1990 - 1992 Corvette ZR-1: Service Bulletin: No Start Condition (Replace Starter)

Subject: NO START CONDITION (STARTER CORROSION-REPLACE STARTER)

Model and Year: 1990-1992 Corvette, Engine Code J (LT5)

Bulletin Number: 92-307-6 - (09/21/1992)

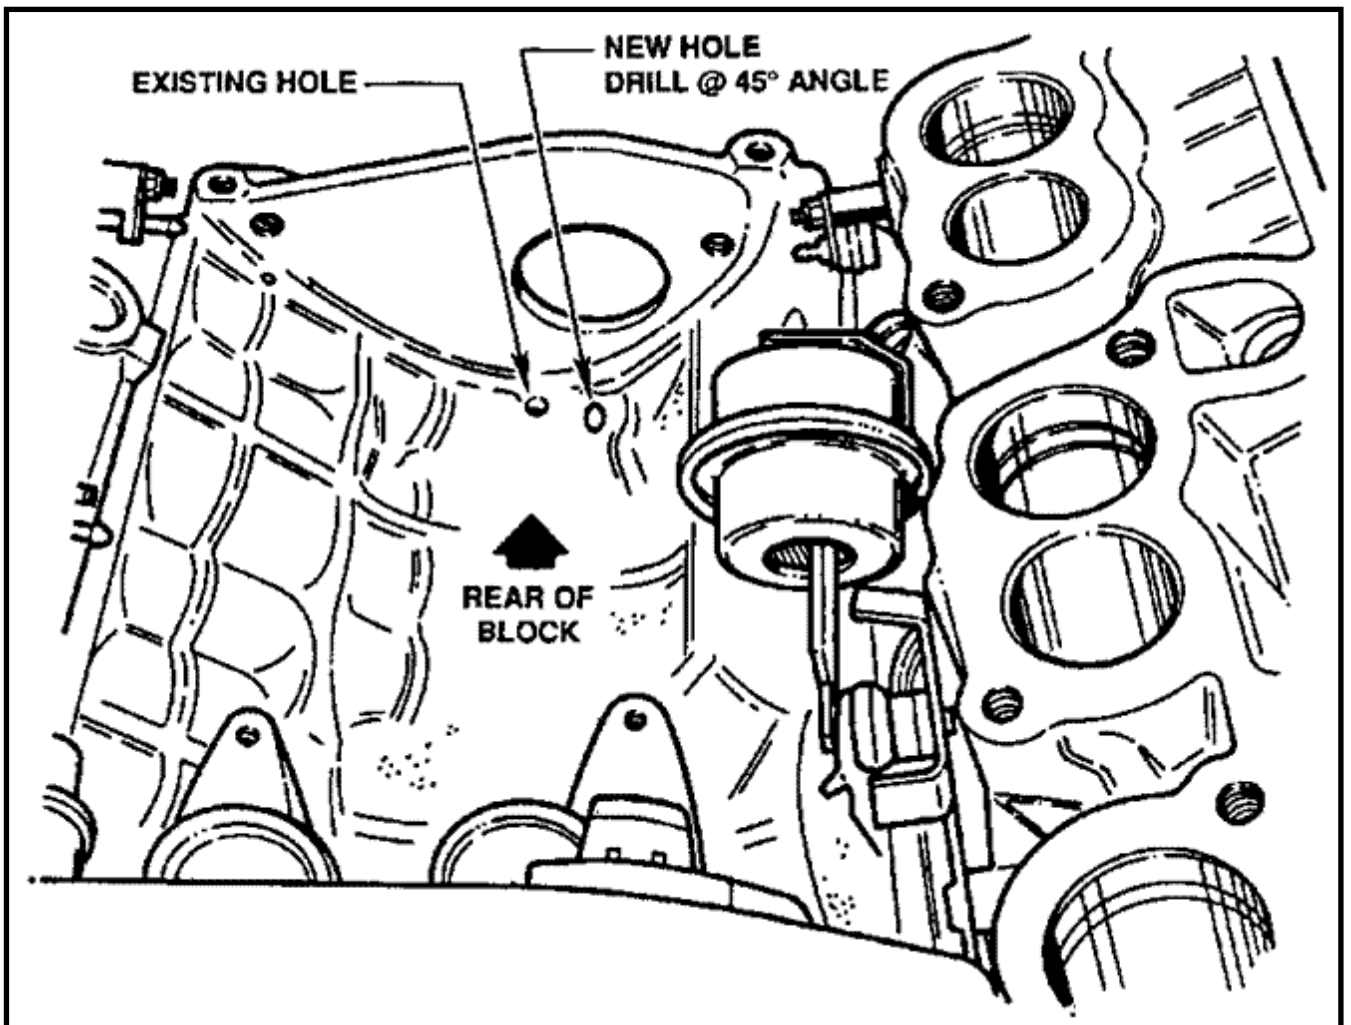
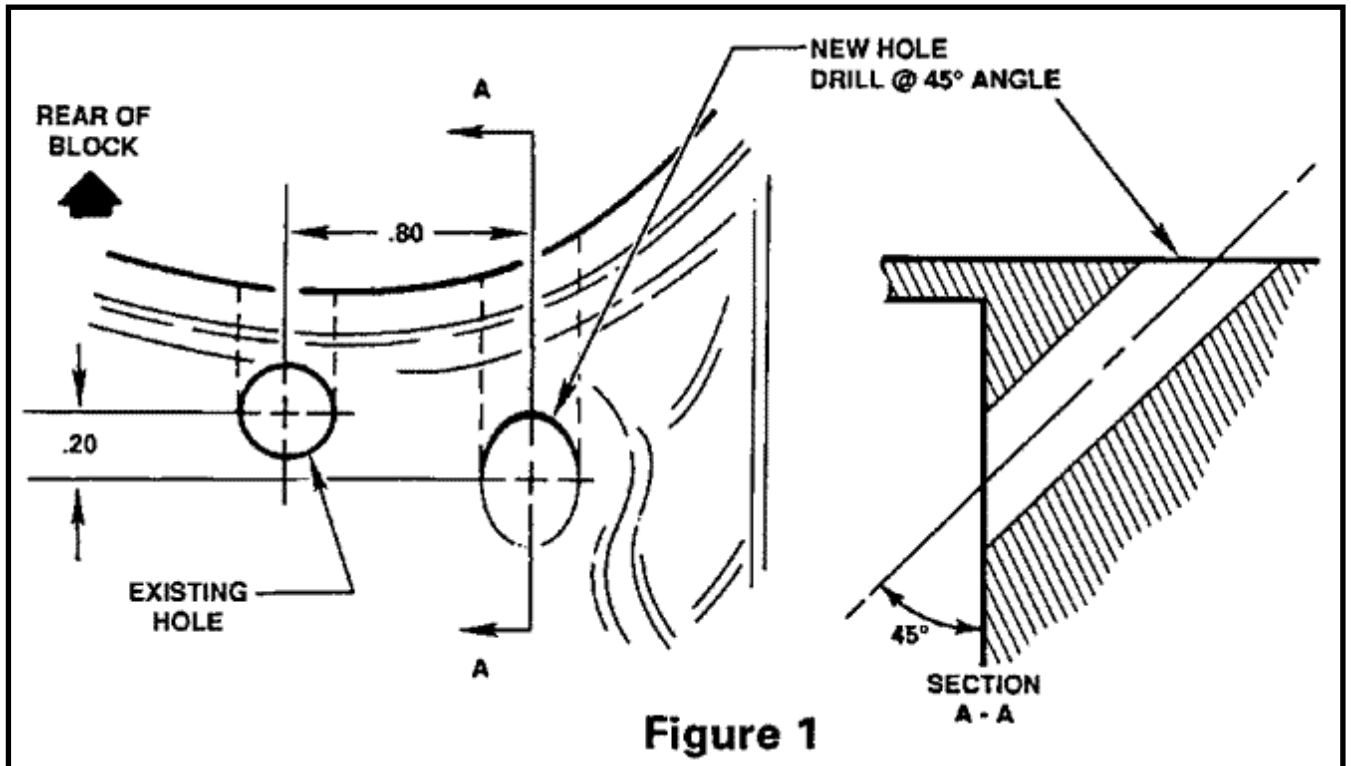
Some ZR1 Corvettes may exhibit a no start condition due to starter corrosion. This condition is most likely to occur after the engine has been washed.

The starter on an LT5 engine is mounted in the engine "vee." A drain hole and drain tube are located at the rear of the engine valley. While washing the engine, debris may settle in the engine "vee" and block the drain system.

- 1 . Remove the old starter.
2. Clean any blockage in existing drain system.
3. Drill a 3/8" diameter hole through the engine "vee" to the back of the engine, allowing drainage (see Figure 1).

4. Install new starter, p/n 10455704.
